PIC24F16KA102 Family Silicon Errata and Data Sheet Clarification

The PIC24F16KA102 family devices that you have received conform functionally to the current Device Data Sheet (DS39927C), except for the anomalies described in this document.

Data Sheet Clarifications

FIGURE 23-2: INDIVIDUAL COMPARATOR CONFIGURATIONS⁽¹⁾

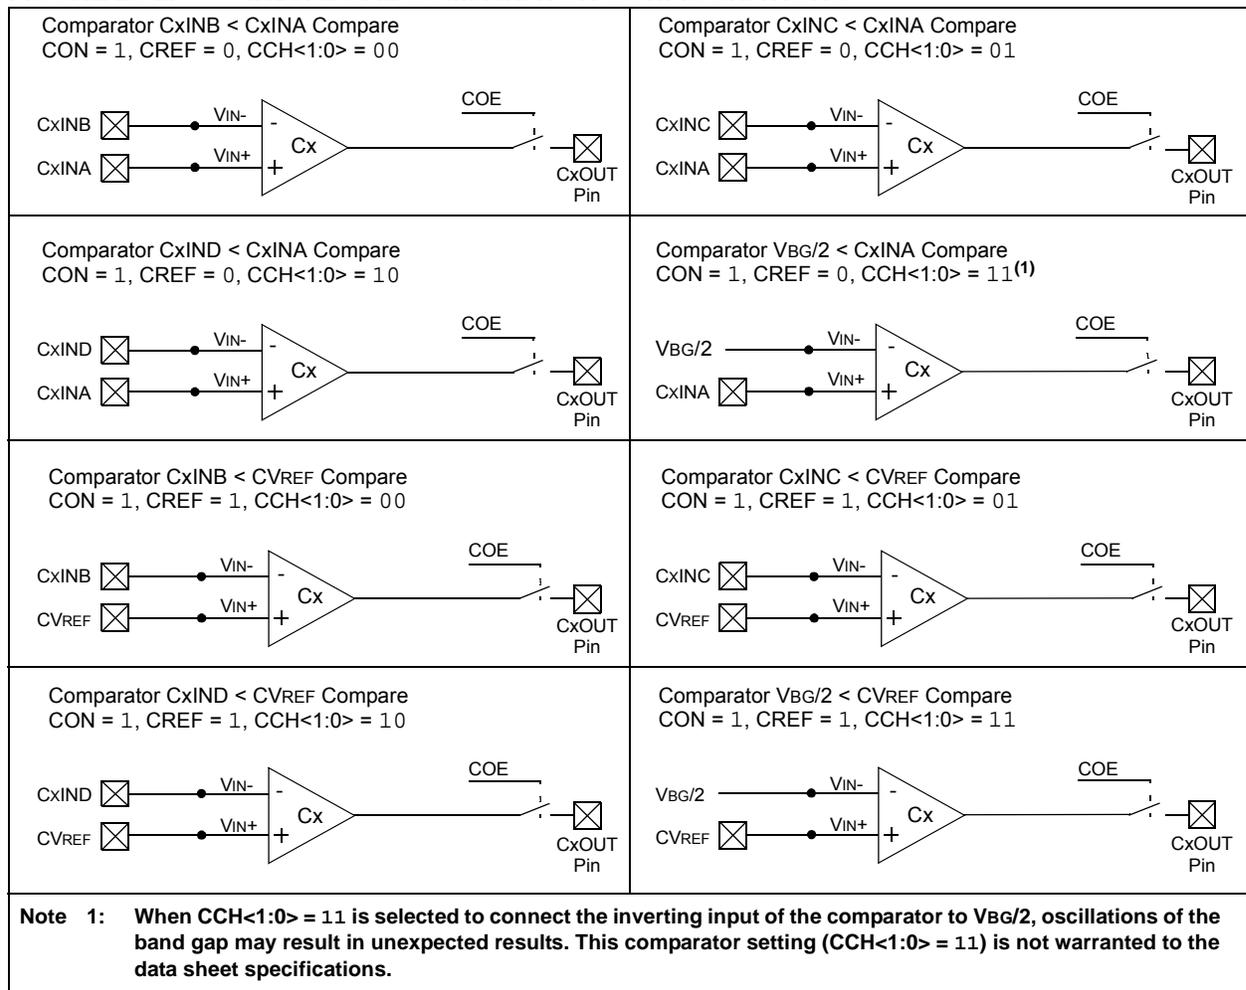
6. Module: Comparator Module

The following note has been added to [Figure 23-2](#) and [Register 23-1](#) below (addition in **bold**).

Note 1: When CCH<1:0> = 11 is selected to connect the inverting input of the comparator to VBG/2, oscillations of the band gap may result in unexpected results. This comparator setting (CCH<1:0> = 11) is not warranted to the data sheet specifications.
